ADDENDUM NO. 4

**Indianapolis International Airport
Indianapolis, Indiana**

Belly Cargo/GSE Maintenance Building

IAA Project No. I-09-033-B

INDIANAPOLIS Airport Authority		SCALE: AS SHOWN	
AIRPORT INDIANAPOLIS INTERNATIONAL AIRPORT		DATE: 11-16-09	
PROJECT BELLY CARGO / GSE MAINTENANCE BUILDING			
SHEET TITLE SAFETY AND PHASING PLAN			
PLANS PREPARED BY RW ARMSTRONG		DESIGNED BAN	DRAWN AEC
		CHECKED BAN	APPROVED SCL
		G105A

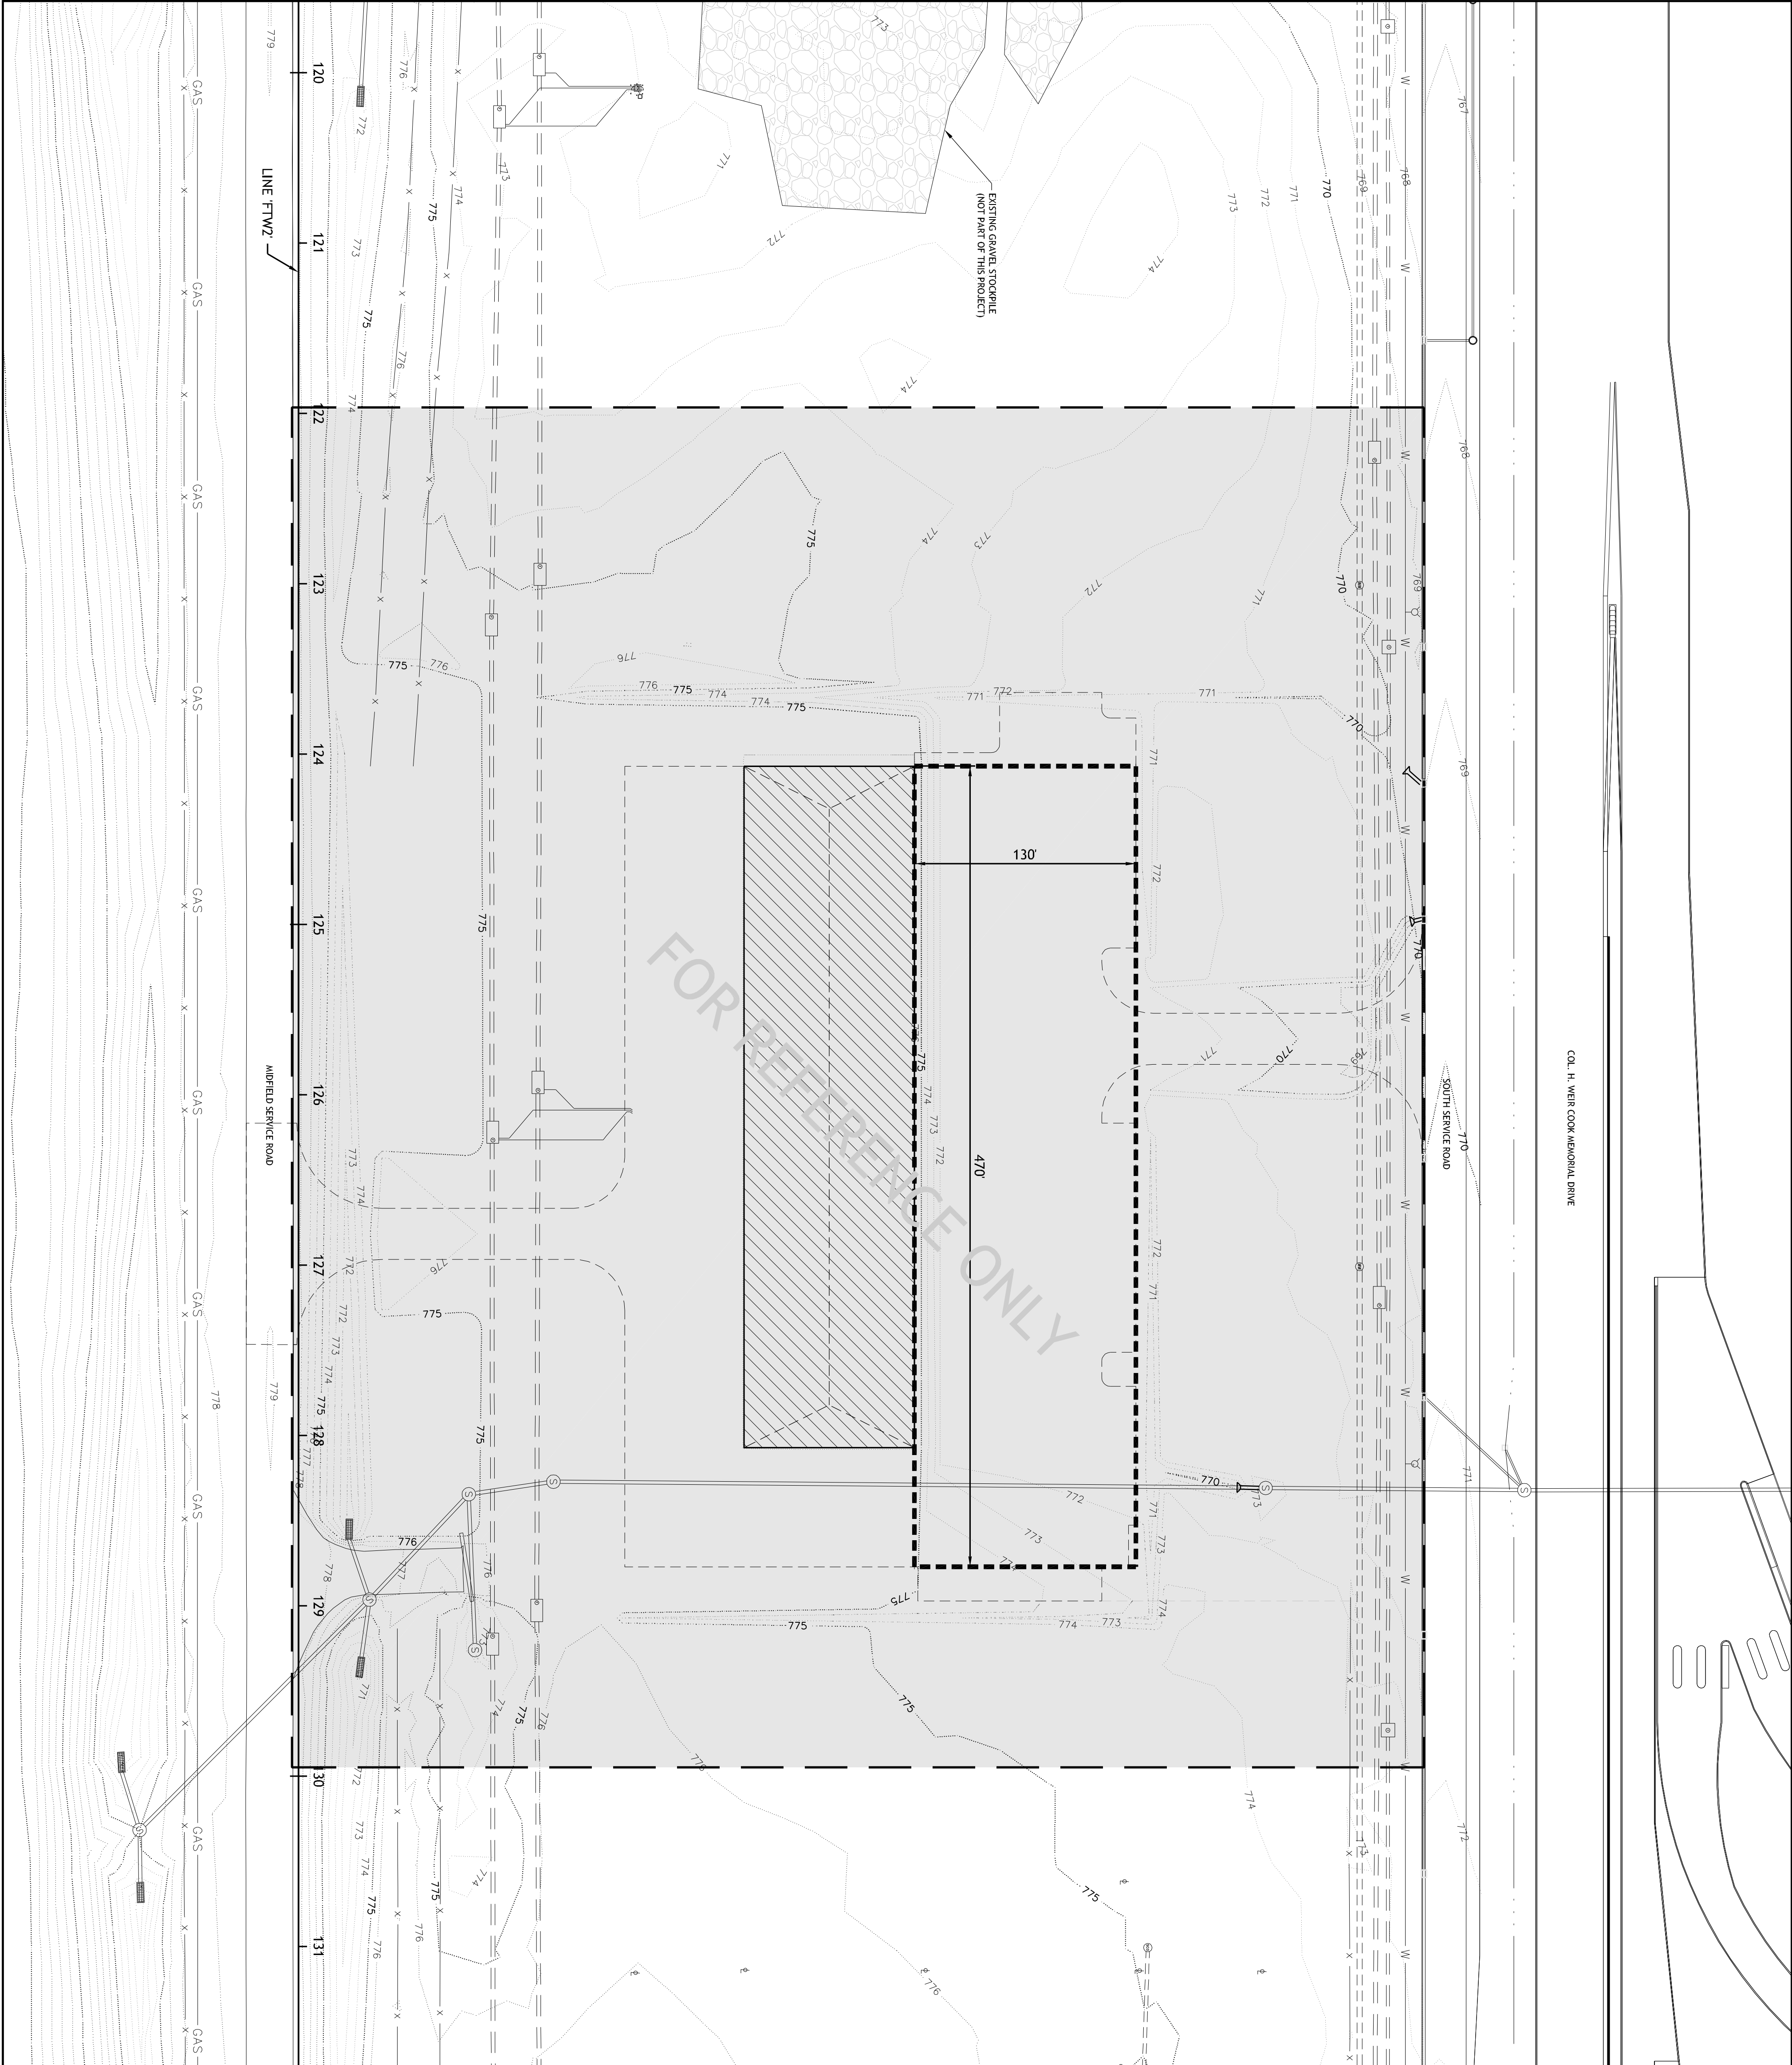
PLAN SHEET G105A – SAFETY AND PHASING PLAN EAST SIDA GATE

Insert: New Plan Sheet G105A, dated 11/16/09 (attached).
